TABLE OF CONTENTS
MINUTES OF THE 403RD ACRS MEETING

November 4-6, 1993

MINUTES OF THE 403RD MEETING OF THE
ADVISORY COMMITTEE ON REACTOR SAFEGUARDS
NOVEMBER 4-6, 1993
BETHESDA, MARYLAND

Figure 1

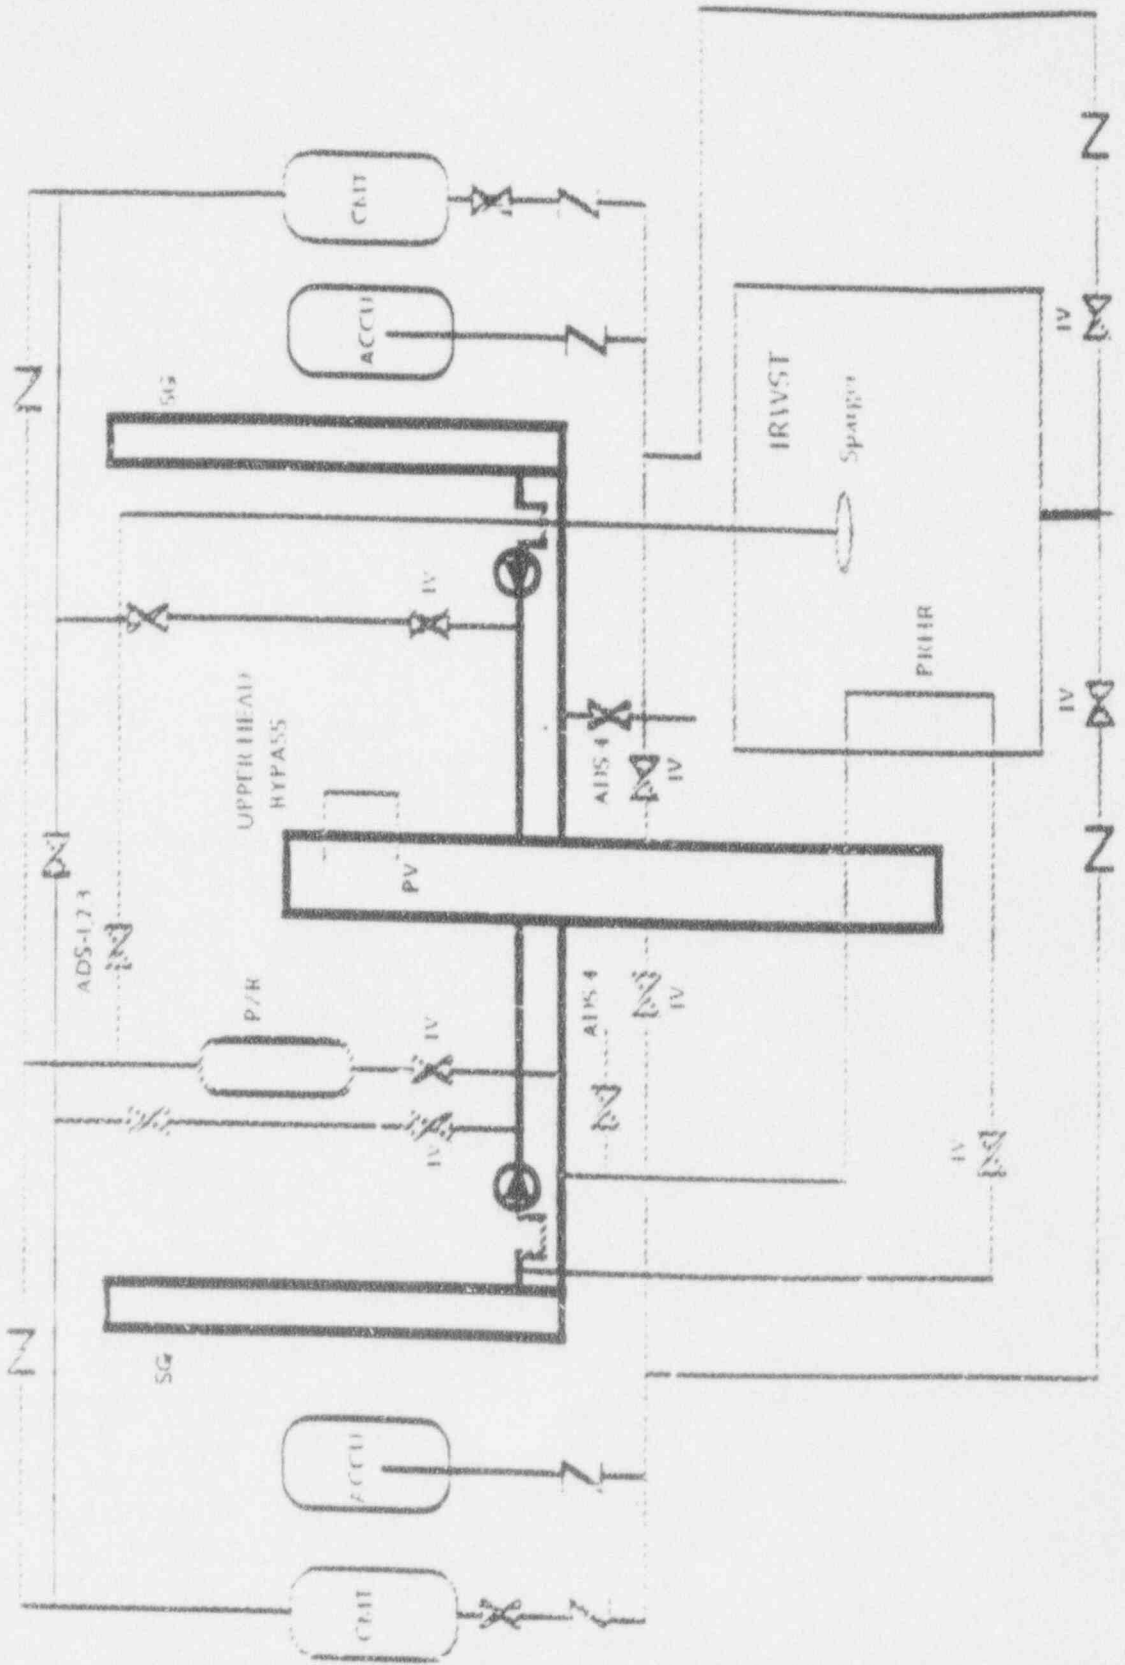
- Noting the modifications made to the facility (Figure 1), Dr. Shotkin said that, with the exception of the pressurizer, all the new equipment can be valved out as desired pursuant to JAERI's desire to conduct their own set of facility tests.

During the discussion following a question from Mr. Carroll regarding the above-noted Consultants' reports, Dr. Catton noted that the Subcommittee objected to RES's use of the RELAP5 code in support of the ROSA scaling analysis. He indicated that a rigorous analysis is called for given the unique analytical challenges posed by the AP600 passive design.
